NEBRASKA ARMY NATIONAL GUARD SIDNEY RC INTERIOR SUSTAINMENT

Sidney Readiness Center
2225 Legion Park Road
Sidney, NE 69162

PROJECT NO. 31030399

A D D E N D U M N O . 2

A1 MAIN LEVEL REFLECTED CEILING PLAN - NEW
A216 SCALE: 1/8"=1'-0"

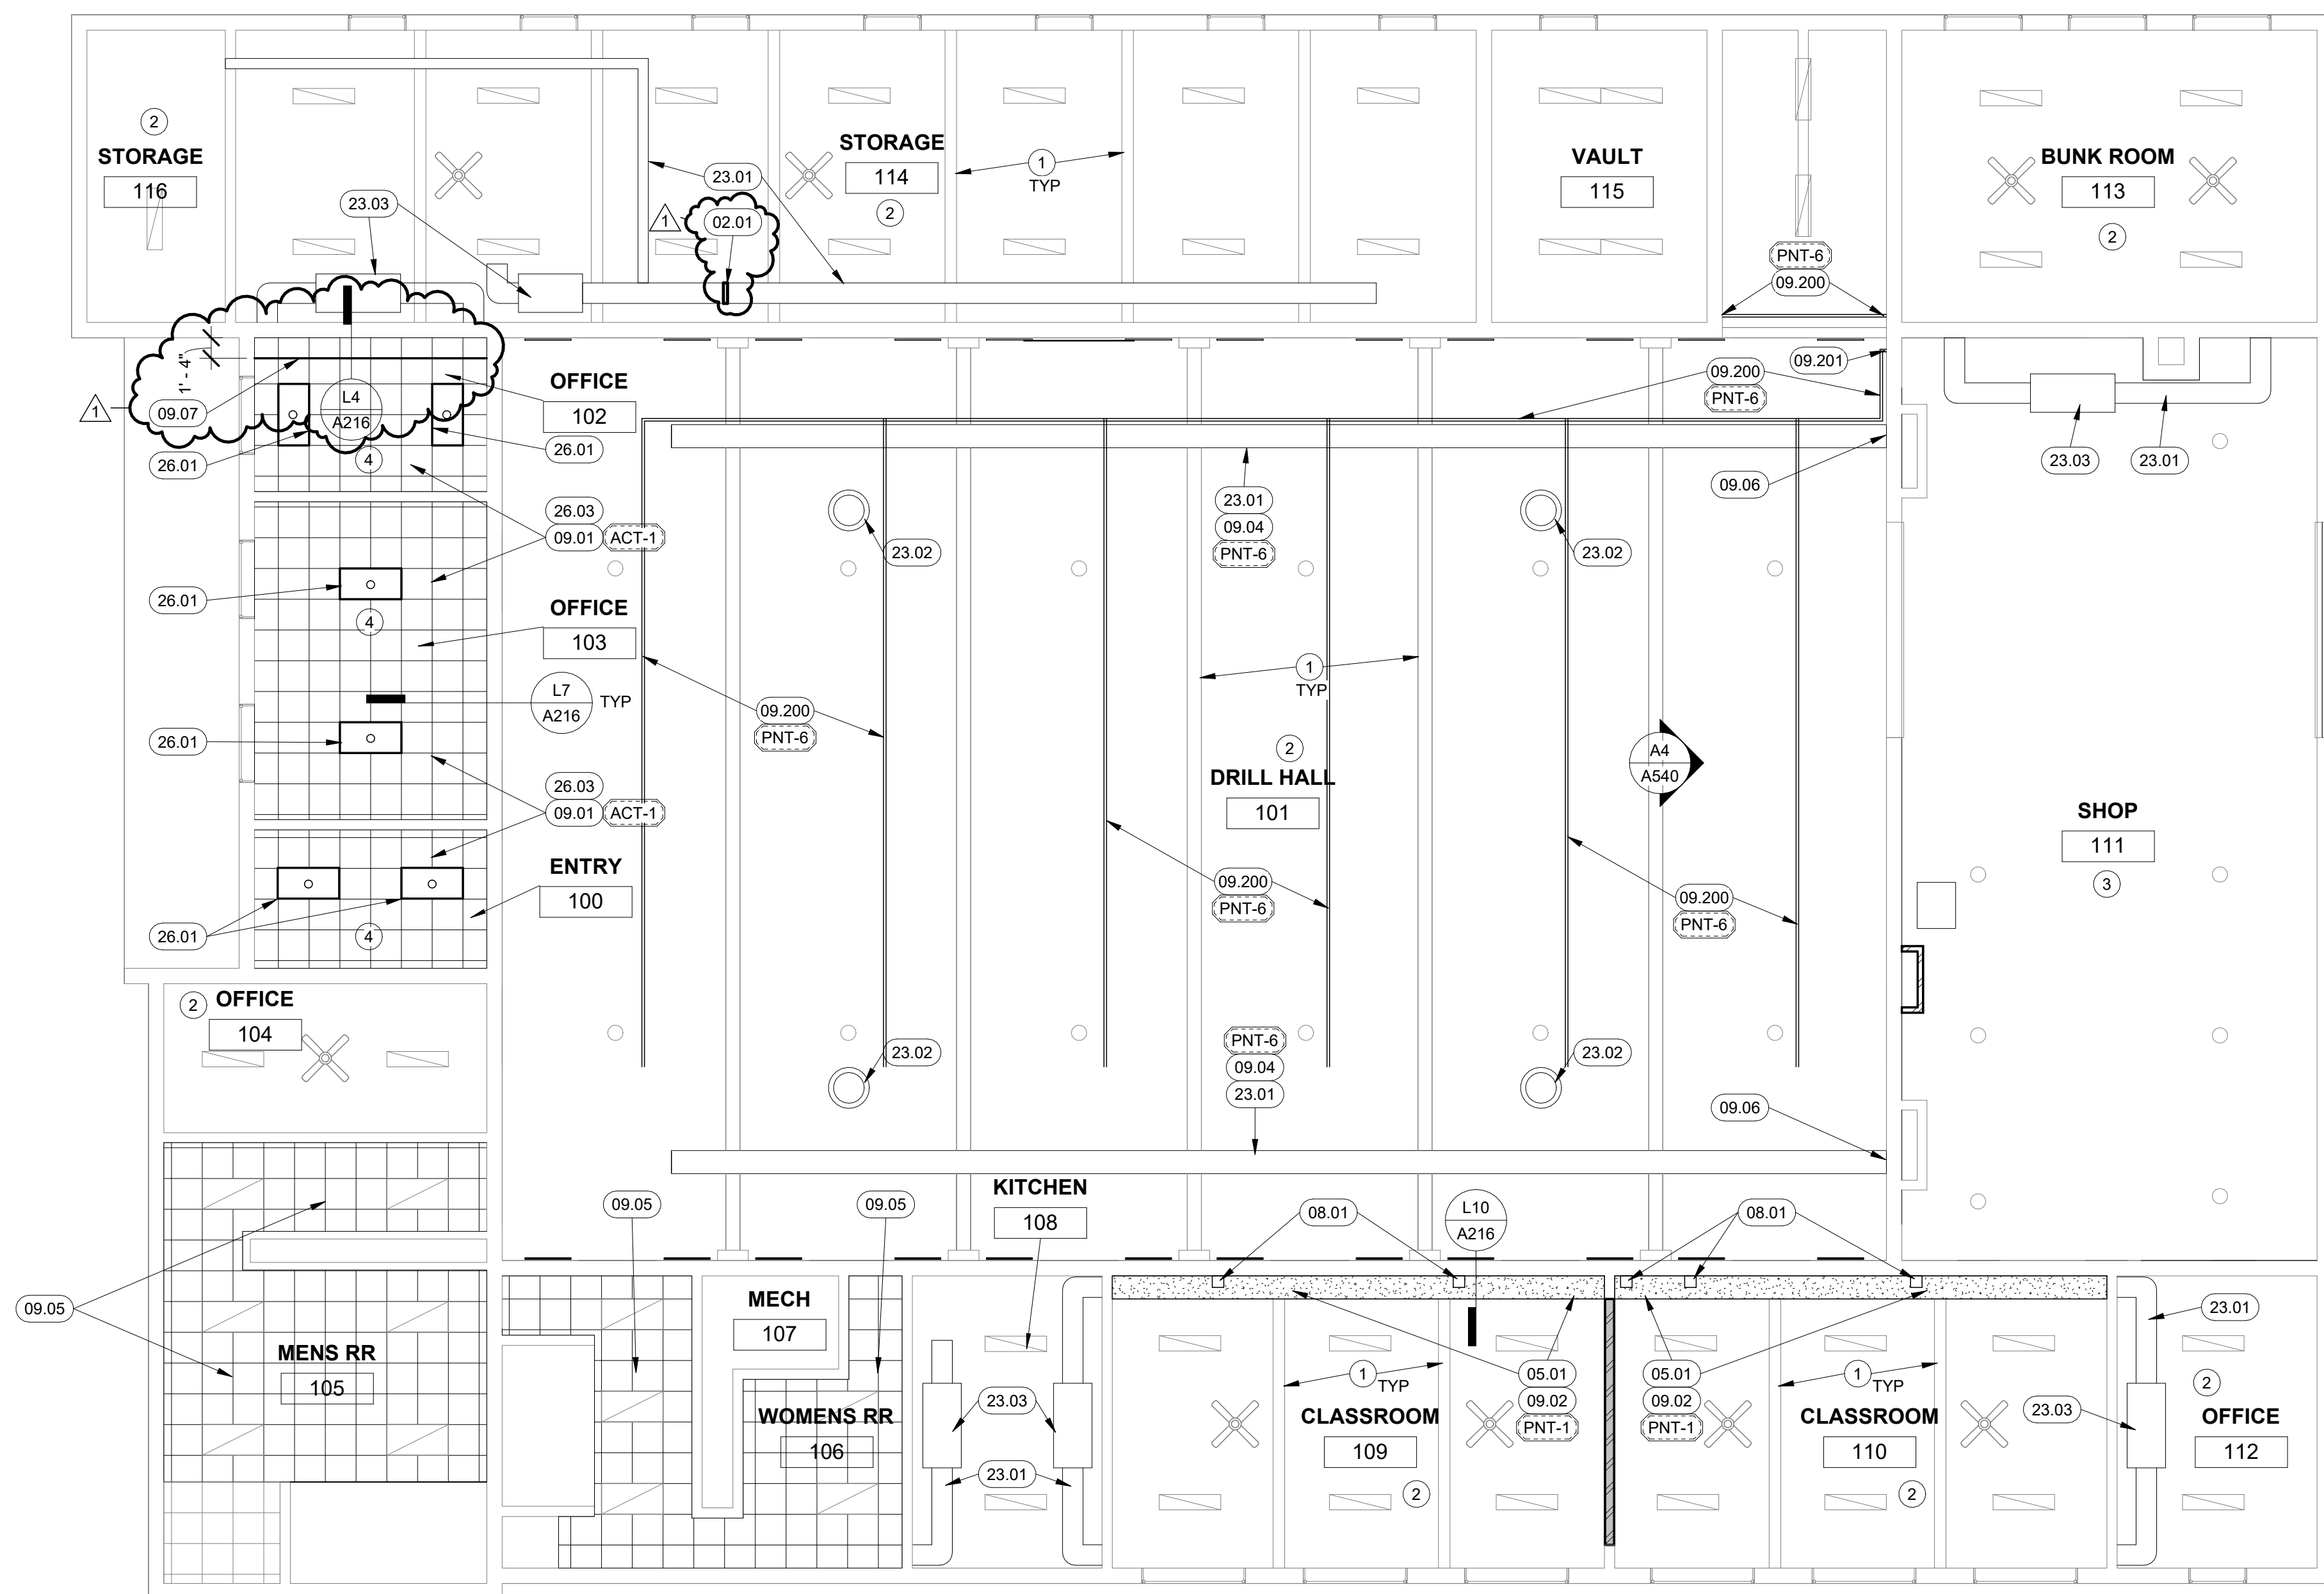
ADD 2-7 Reference Drawing A216 Main Level Reflected Ceiling Plan – New:

1. Detail A1, Main Level Reflected Ceiling Plan – New
 - a. Add ceiling transition detail at Office 102.
 - b. Add section callout L4/A216 for ceiling transition trim detail.
 - c. Add keynote 02.01, “Cut existing storage caging for new duct work.” at new duct in Storage 114.
2. Add detail L4 Ceiling Transition Detail for ceiling transition detail.

C1 BASEMENT PLAN - FIRE PROTECTION
F101 SCALE: 1/8"=1'-0"

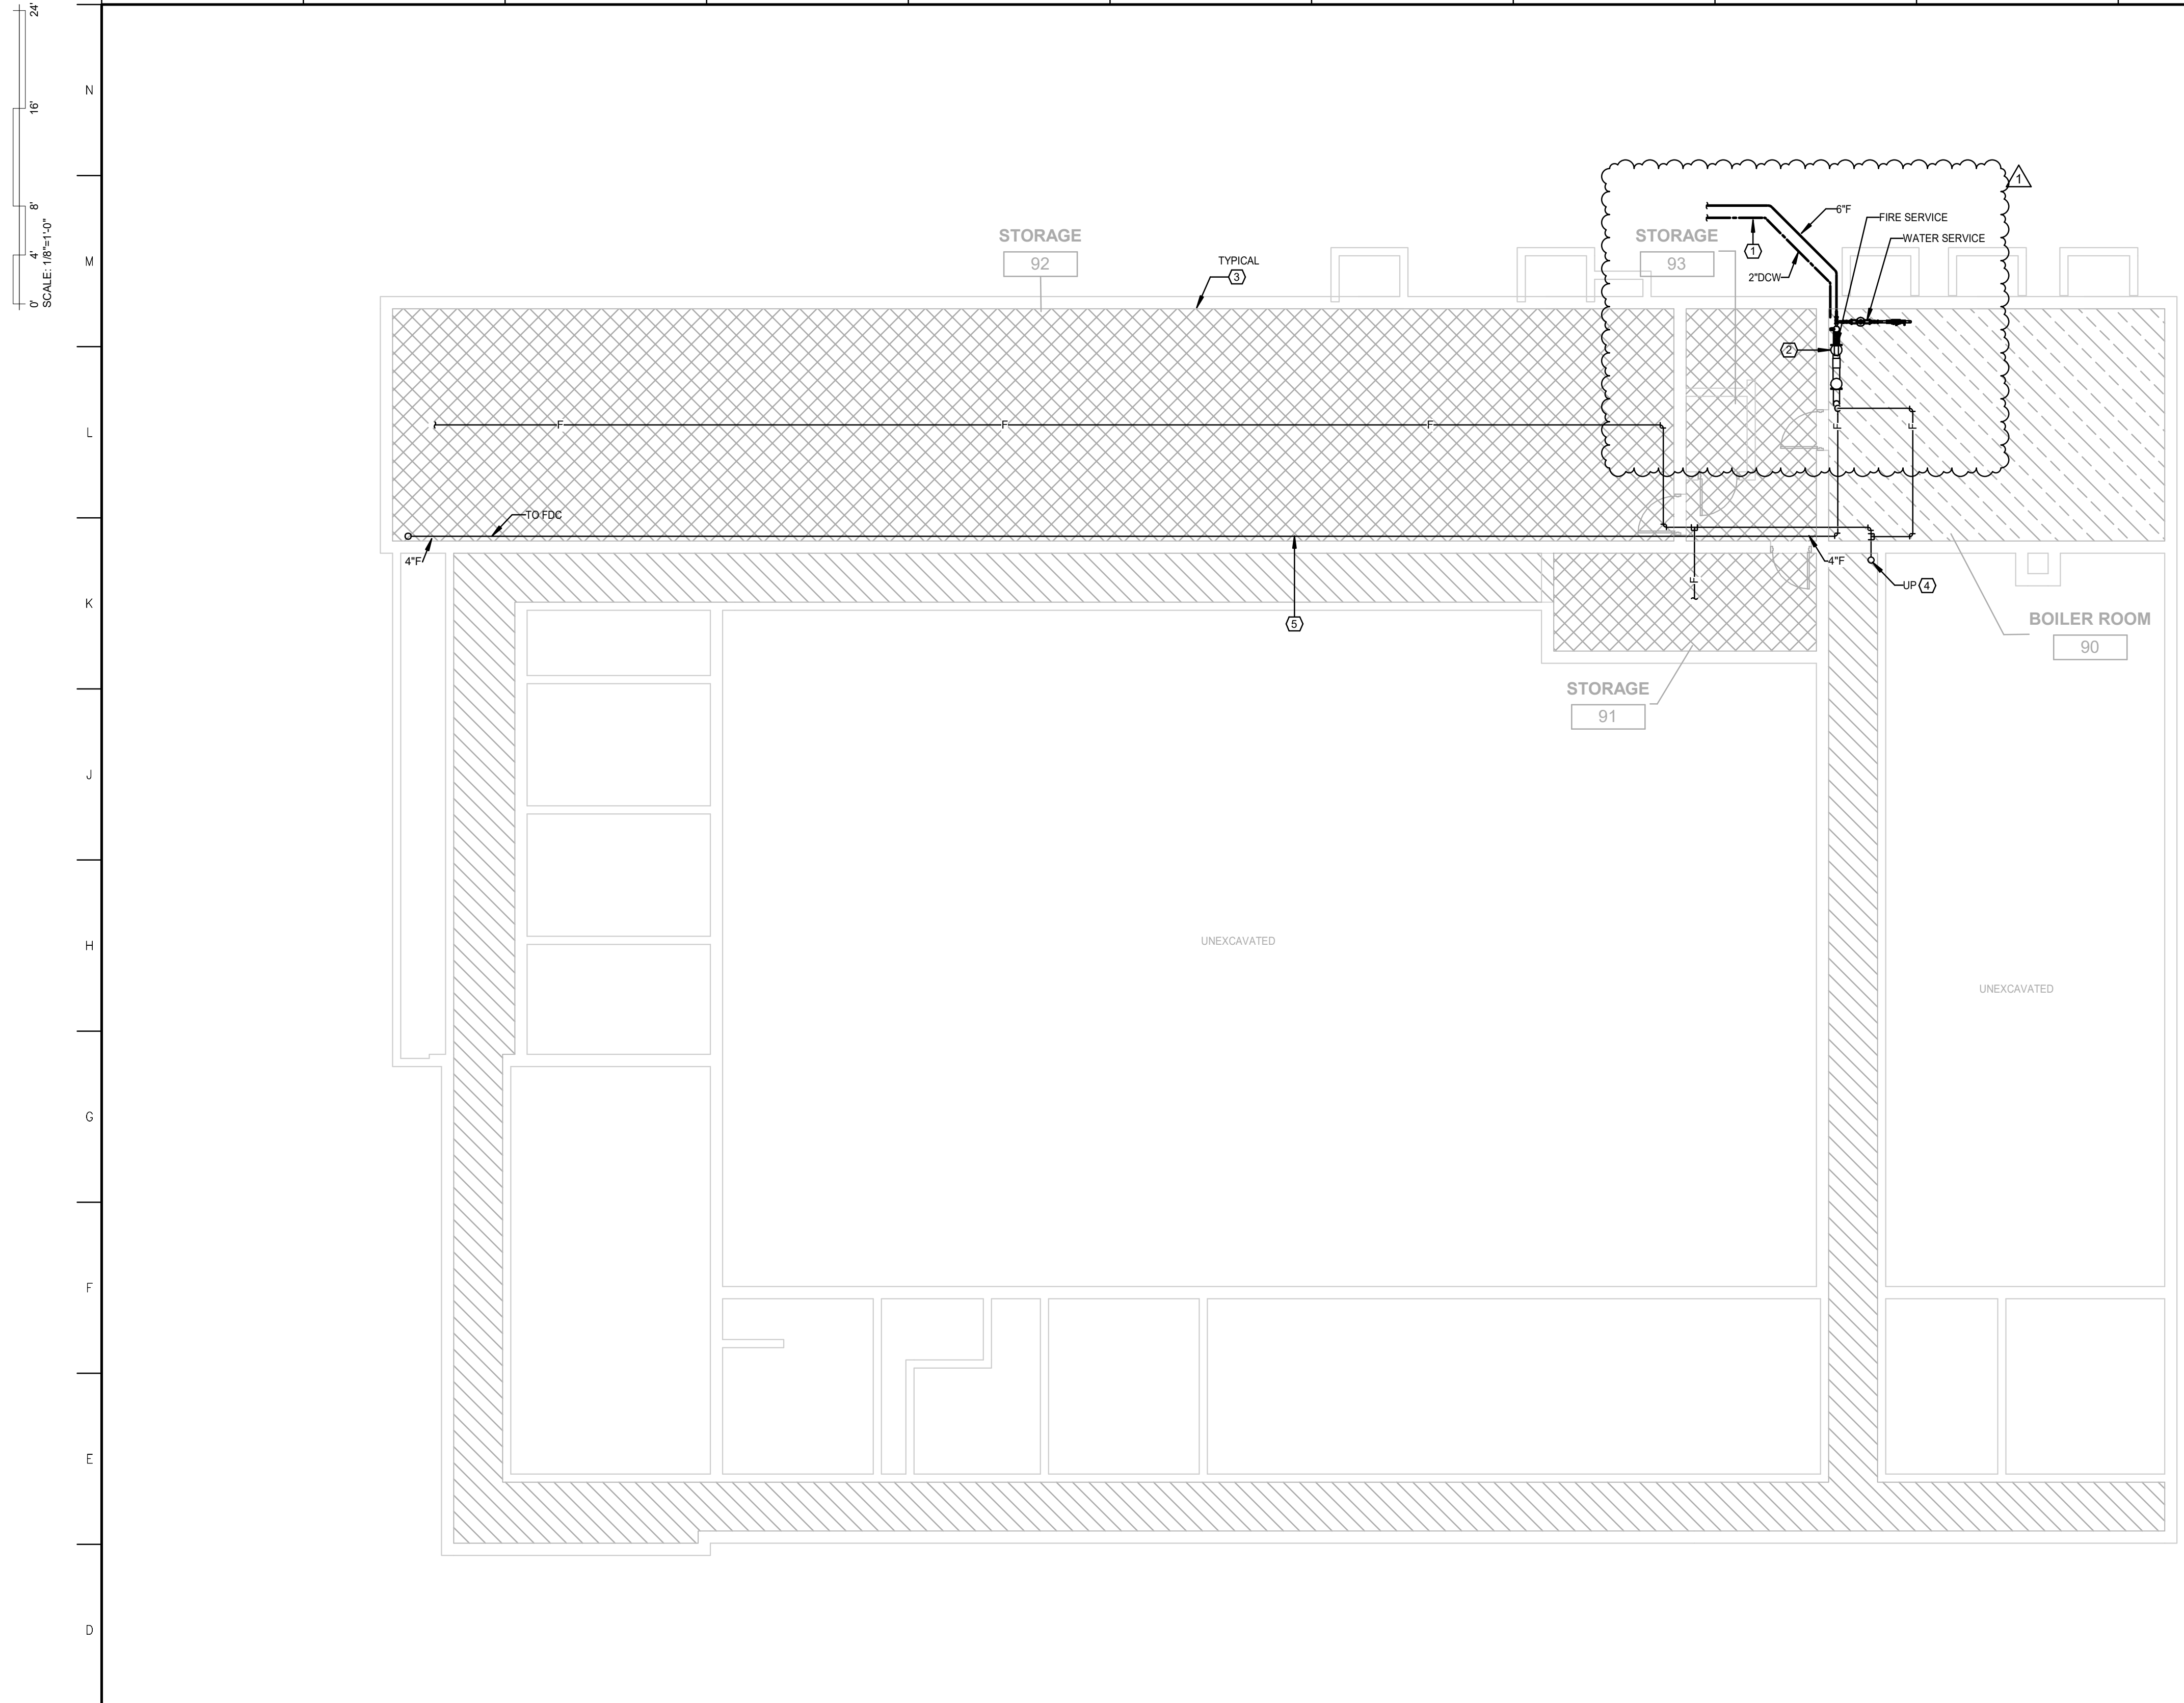
Sheet F101 – BASEMENT PLAN – FIRE PROTECTION

- The Combination Fire & Water Service has been separated into two separate entrances to accommodate the required PIV.
- A new 2" water service is to extend into the building alongside the new 6" fire service, see Civil plan for routing of water lines into building.
- Refer to revised drawing for NFPA 13 Fire Service Entrance Detail.

C1 BASEMENT PLAN - HVAC PIPING
M102 SCALE: 1/8"=1'-0"

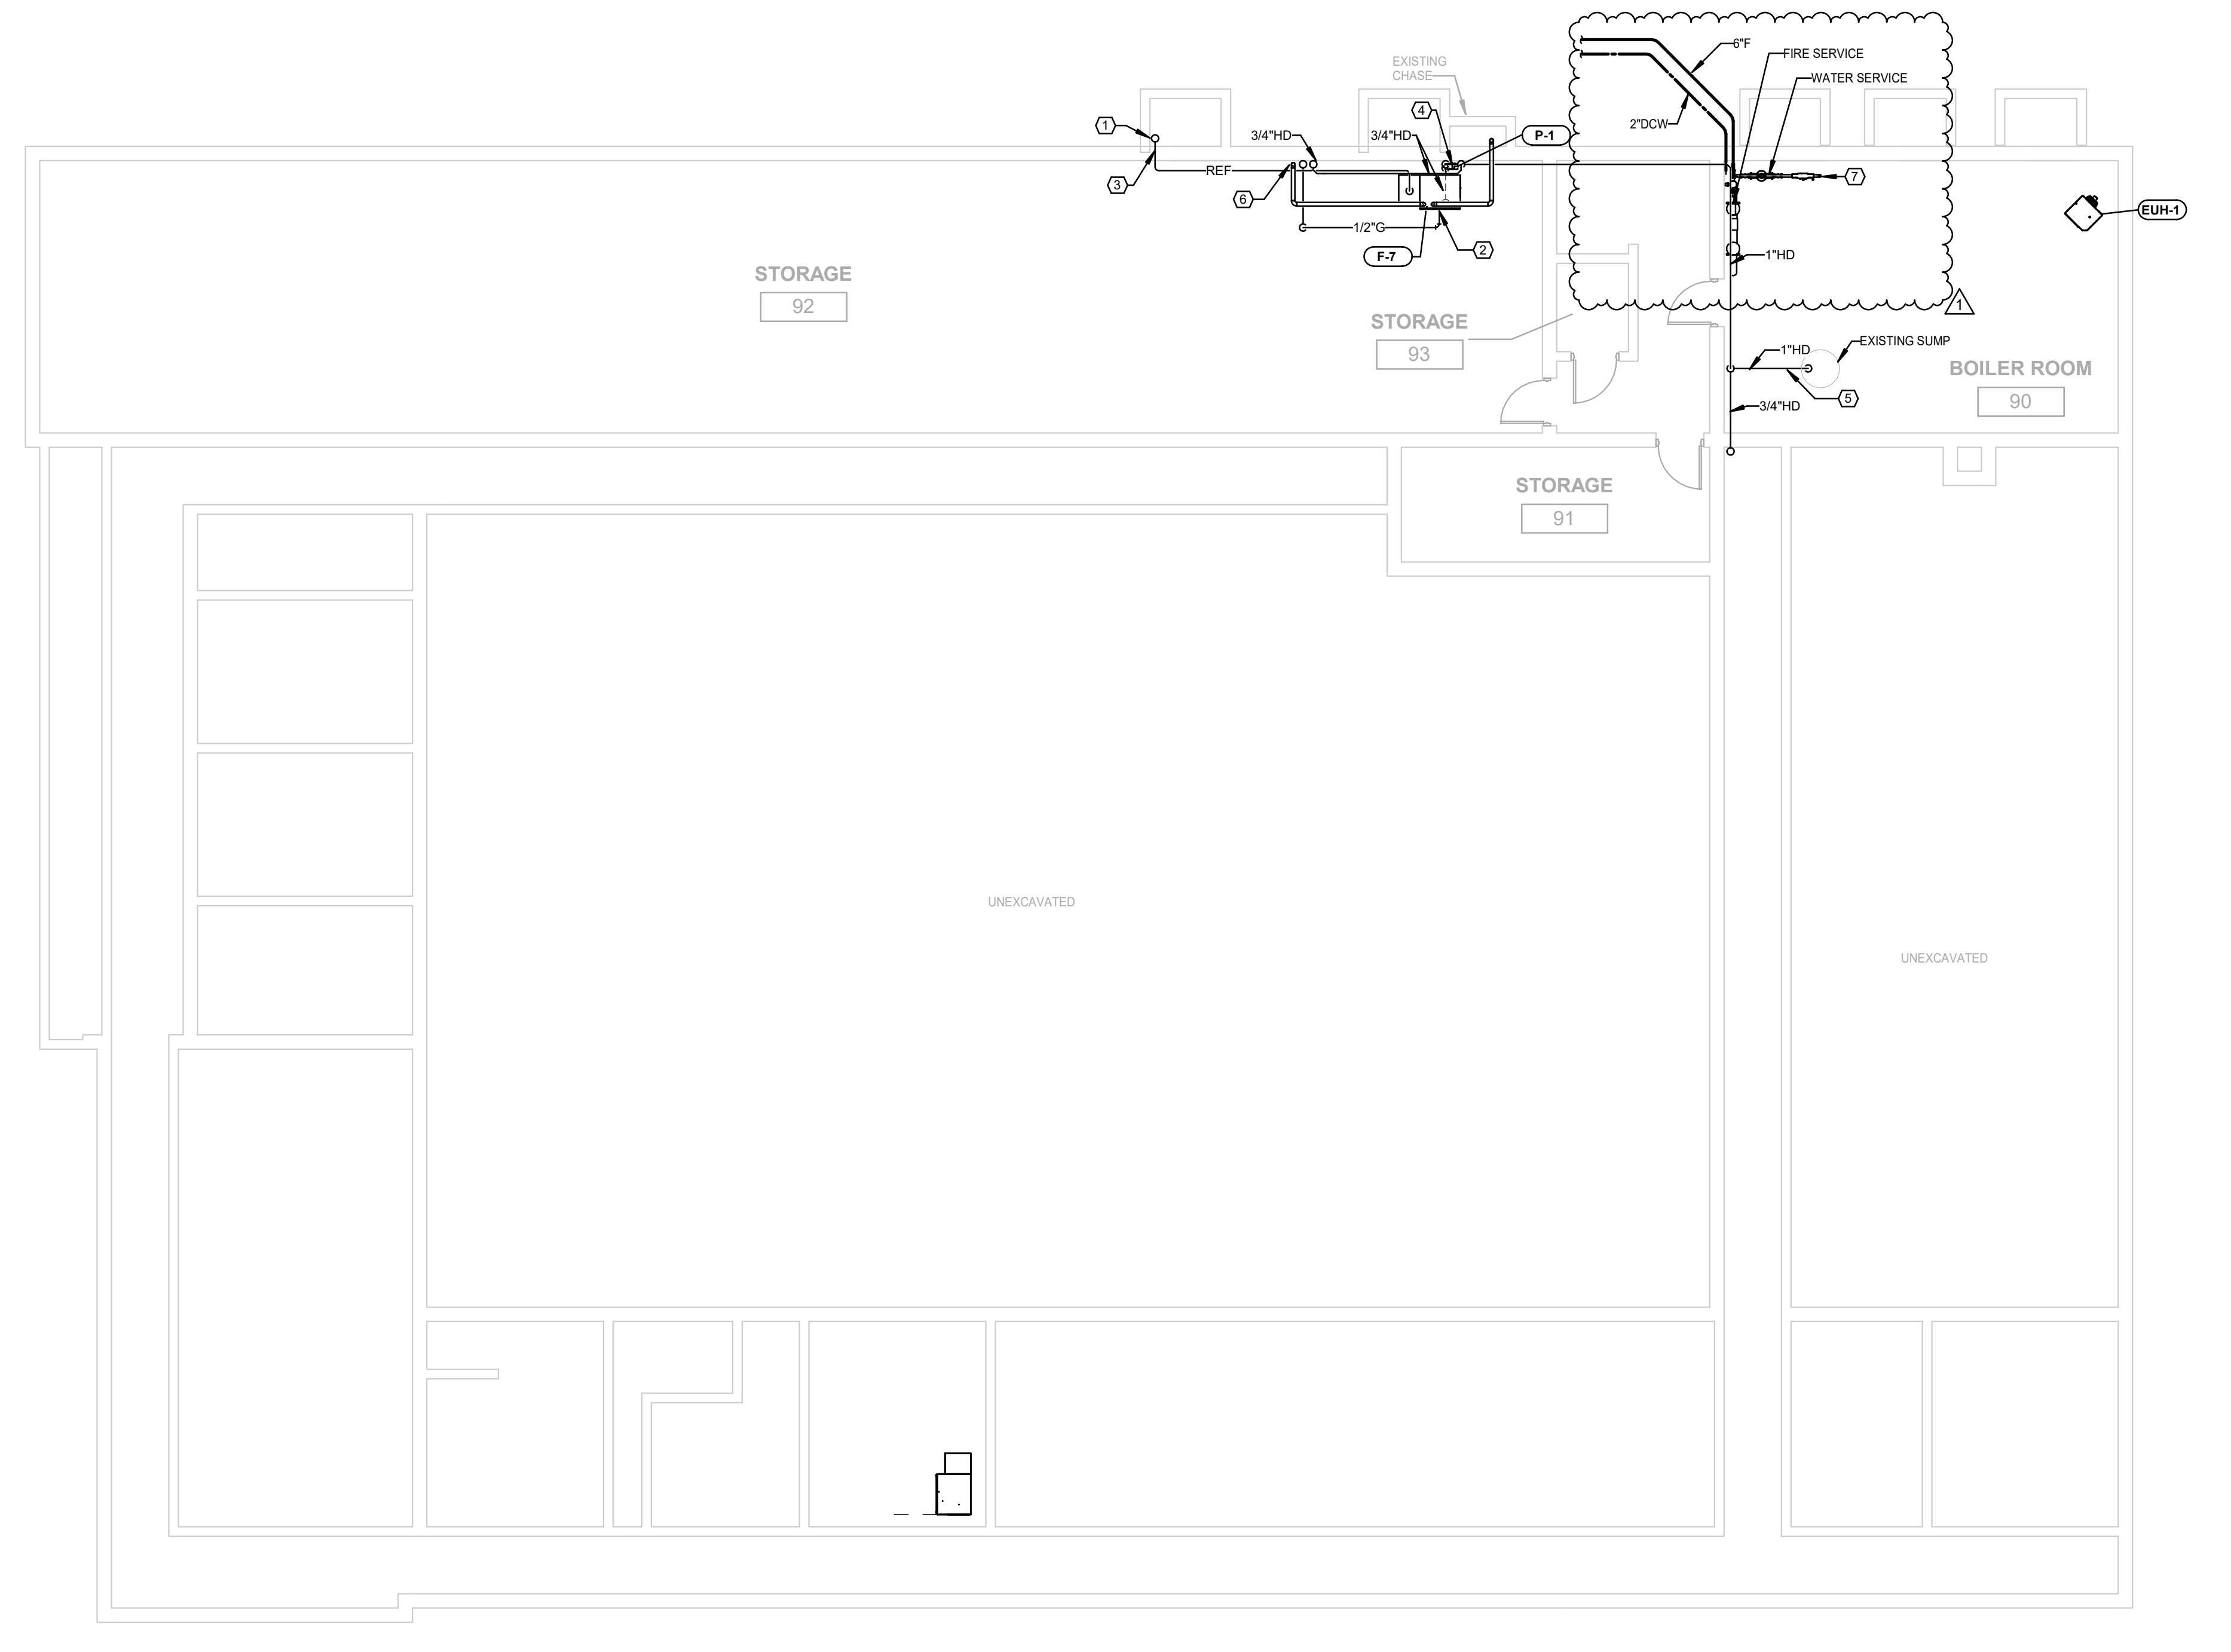
Sheet M102 – BASEMENT PLAN – HVAC PIPING

- The Combination Fire & Water Service has been separated into two separate entrances to accommodate the required PIV.
- A new 2" water service is to extend into the building alongside the new 6" fire service, see Civil plan for routing of water lines into building. The new 2" water main shall be provided with proper backflow prevention and meter. The new 2" line shall be connected to the existing 2" water feed located in the boiler room.
- Refer to revised drawing for Water Service Entrance Detail.
- See revised drawing for new Sheet Note 7.
